CITY OF HOBART

COUNCIL MEETING

**7.2.1 79 COLLINS STREET, HOBART AND ADJACENT ROAD RESERVE
- PARTIAL DEMOLITION AND NEW BUILDING FOR VISITOR
ACCOMMODATION, HOTEL INDUSTRY, FOOD SERVICES, AND
COMMUNITY MEETING AND ENTERTAINMENT, AND ASSOCIATED
WORKS
PLN-20-911 - FILE REF: F21/60432**

That pursuant to the *Hobart Interim Planning Scheme 2015*, the Council refuse the application for partial demolition and new building for visitor accommodation, hotel industry, food services, and community meeting and entertainment, and associated works, at 79 Collins Street, Hobart for the following reasons:

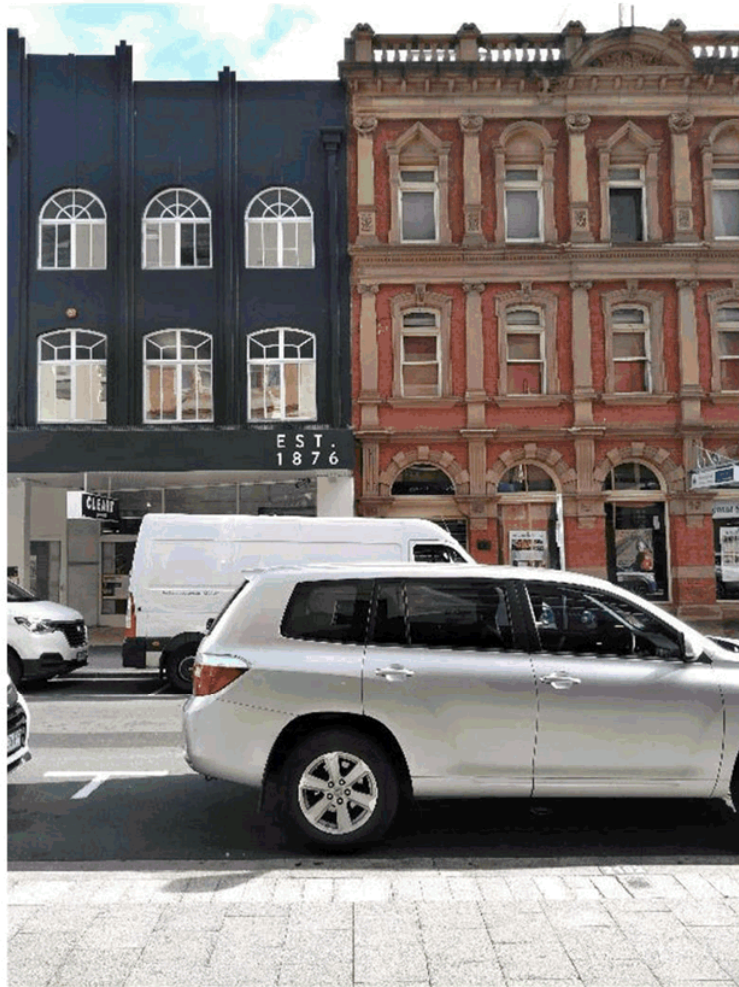
The proposal does not meet the acceptable solution or the performance criteria with respect to clause E 13.7.1P1 (a) to (d) of the *Hobart Interim Planning Scheme 2015* because the proposed demolition will result in the loss of 19th century and 20th century significant fabric, items and form that contribute to the historic cultural heritage significance of the place and it has not been reasonably demonstrated that: there are environmental, social, economic or safety reasons of greater value to the community than the historic cultural heritage values of the place; or that there are no prudent or feasible alternatives; or that important structural or facade elements that can feasibly be retained and reused in a new structure are retained or that significant fabric is documented before demolition.

The proposal does not meet the acceptable solution or the performance criteria with respect to clause E 13.7.2 P1 (a) and (b) of the *Hobart Interim Planning Scheme 2015* because it is an incompatible design through its height, scale, bulk, form, fenestration and siting behind a three storey heritage listed buildings and it also results in the substantial diminution of heritage values though the loss of features, fabric and items that contribute to the significance of the place.

The proposal does not meet the acceptable solution or the performance criteria with respect to clause E 13.7.2 P2 (a) to (d) of the *Hobart Interim Planning Scheme 2015* because it will not be subservient and complementary to the listed place due to its bulk, scale, materials, built form, setback and siting in respect to listed elements.

The proposal does not meet the acceptable solution or the performance criteria with respect to clause E 13.7.2 P3 of the *Hobart Interim Planning Scheme 2015* because it does not respond to the dominant heritage characteristics of the listed place in its materials, fenestration and built form.

Timber stairs - proposed to be demolished.

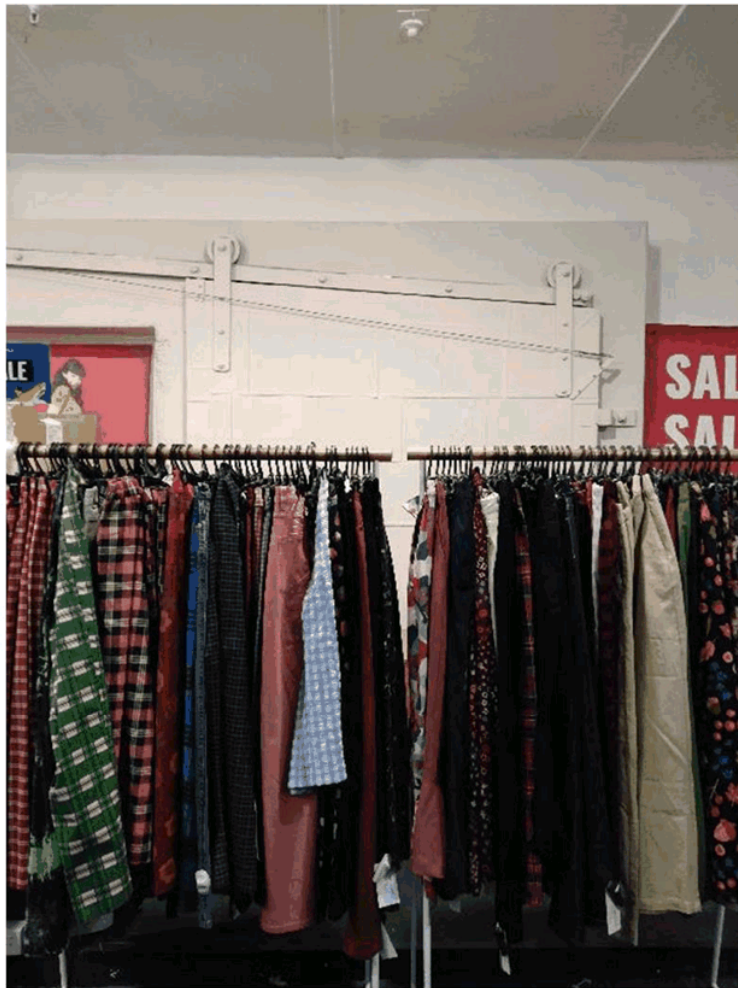
Timber details

Pressed tin ceiling

Cargo door
